# HUKILL CHEMICAL CORPORATION

Thank you for your June 18, 1991 response to Ohio EPA's Notice of Deficiency dated March 11, 1991.

We have enclosed technical adequacy comments that are the result of this review. Please provide detailed information addressing all areas indicated on the comment sheets to Ohio EPA within 45 days of the date of receipt of this correspondence. This submission shall be in accordance with the following editorial protocol or convention:

FIG. G 2

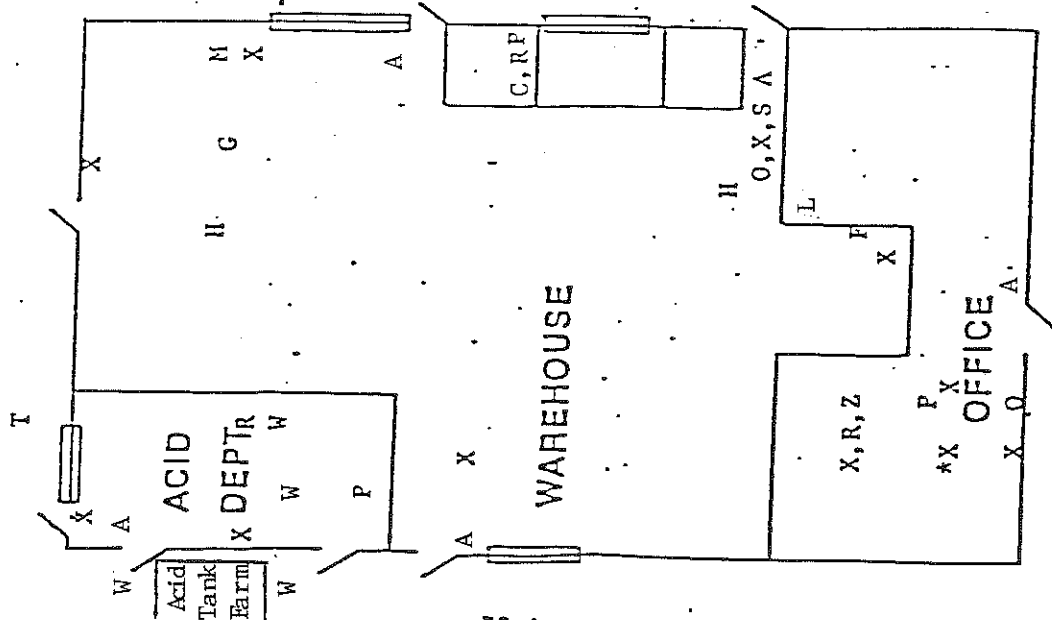
Figure G-2 must be revised to show locations of:
